21555 Non-Transparent PCI-to-PCI Bridge

Specification Update

December 2002

Order Number: [278337-008](#)

Figure 6. 304 PBGA (Four-Layer) Package

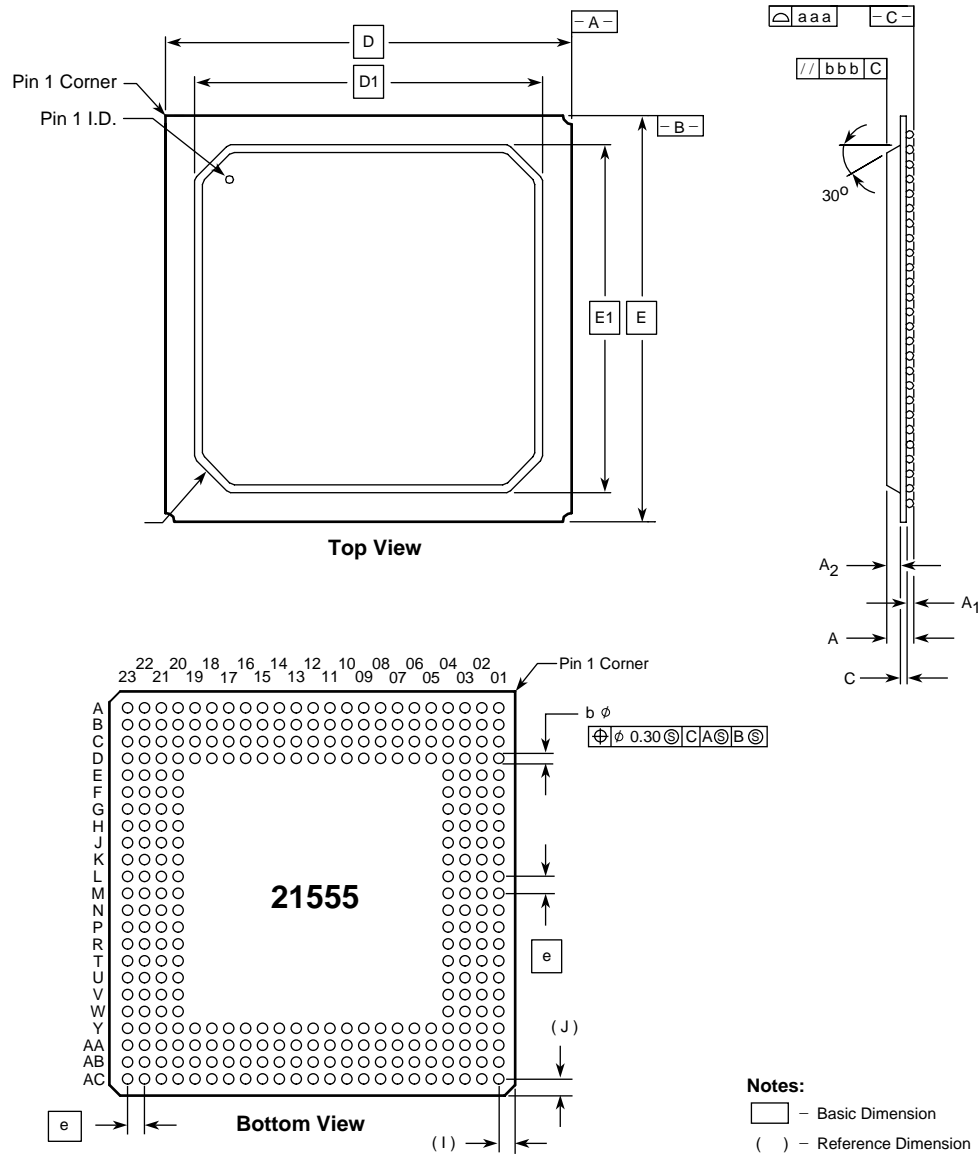
1. **PBGA Package Dimensions for coplanarity changed from maximum value 0.15 mm to maximum value 0.2 mm.**

Per PCN notification 961, the 304-point 4-layer PBGA package dimensions for symbol aaa, coplanarity, are changed from maximum value 0.15 mm to maximum value 0.2 mm.

Issue: The maximum value for symbol aaa, dimension coplanarity, has been changed from 0.15 mm to a value of 0.2 mm.

Figure 1. Node Boundary

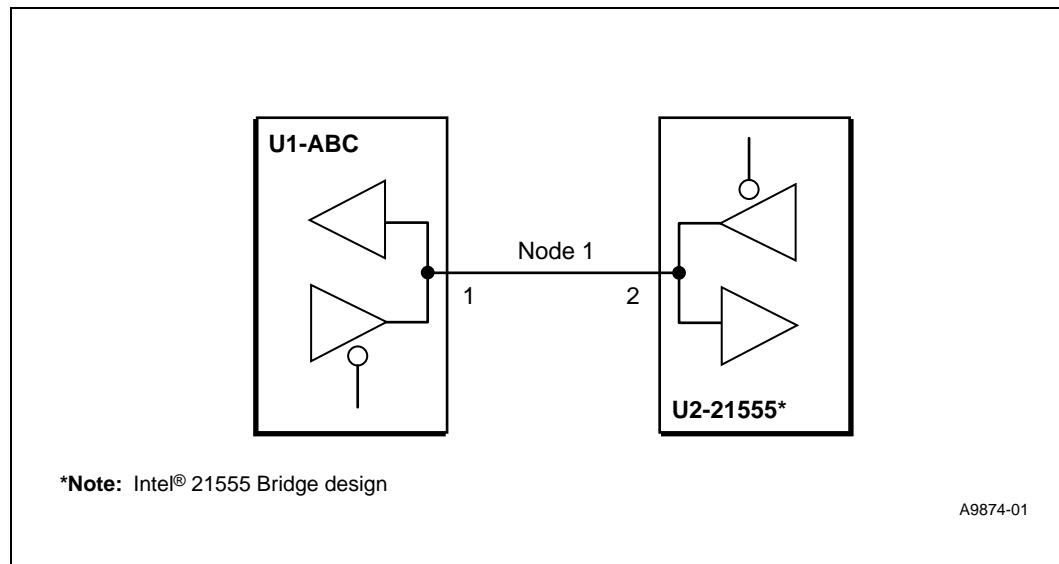
Workaround 2: Standalone boundary scan testers and In-Circuit testers performing chained boundary scan tests, should understand that the Parallel Output UPDATE data, being delayed by one clock, may cause bus contention and back driving during that one clock period, assuming the vectors change bus driving sources in one vector. This is because in chained boundary scan tests, all components execute TAP instructions in Parallel (or lock step), and vector generation algorithms optimize the number of vectors.

To understand the potential issue in detail, refer to the diagram below. Node 1 is a bi-directional node, with U1.1 and U2.2 connected as shown. Assuming that U1 is an IEEE1149.1 compliant device, that U2 is the 21555, and that the control cells of the 21555 were set during the vectors to enable the driver of U2.2 to drive to U1.1 (receiver). When switching drivers from U2 to U1, U2 should tri-state its driver prior to, or at the same time as, U1 enables its driver. Since the 21555 UPDATES its Parallel Outputs one clock late and the control cells which enable U2's drivers are Parallel Outputs which again updates one clock cycle late then U2.2, which will be driving at the same time U1.1 is driving. This contention will happen for one TCK cycle, until U2 UPDATES its parallel outputs. The period of this contention is dependent on the TCK frequency rate.

A remedy to the 21555's late UPDATE is to ensure the chained Boundary Scan tester's vectors do not switch bus driver directions in one vector. This means that one vector should disable U2's driver, and the next vector should enable U1's driver. ATPG vectors typically are not manually manageable in this way and this requirement may force an engineer's manual intervention. No single stepping of test clock through the TAP State Machine should be allowed with the 21555 in the boundary scan chain. The resulting contention would increase the potential back drive time, increasing the possibility of device damage.

Status: Fixed. This behavior has been corrected in the 21555AB/BB Step A3 device.

Figure 12-1. Signal trst_I States

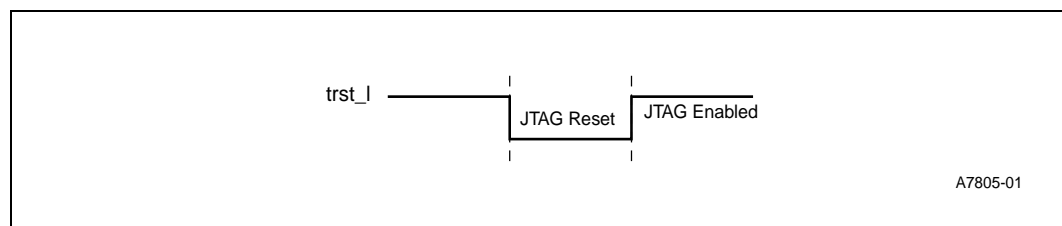
13. Change to Initialization Section 12.2.1 and JTAG Description

Issue: Change to second paragraph. Also made a change to normal operation description note for JTAG below Figure 12-1. The section now appears as follows:

The test access port controller and the instruction register output latches are initialized and JTAG is disabled while the **trst_I** input is asserted low (see Figure 12-1). While signal **trst_I** is low, the test access port controller enters the test-logic reset state. This results in the instruction register being reset which holds the bypass register instruction. During test-logic reset state, all JTAG test logic is disabled, and the device performs normal functions. The test access port controller leaves this state only after **trst_I** (low) goes high and an appropriate JTAG test operation sequence is sent on the tms and tck pins.

For the 21555 to operate properly, the JTAG logic must be reset. The controller resets:

- Asynchronously with the assertion of **trst_I**.
- Synchronously after five **tck** clock cycles, with **tms** held high.

Note: Prior to normal 21555 operation, this signal must be strobed low or pulled low with a 1kΩ resistor.
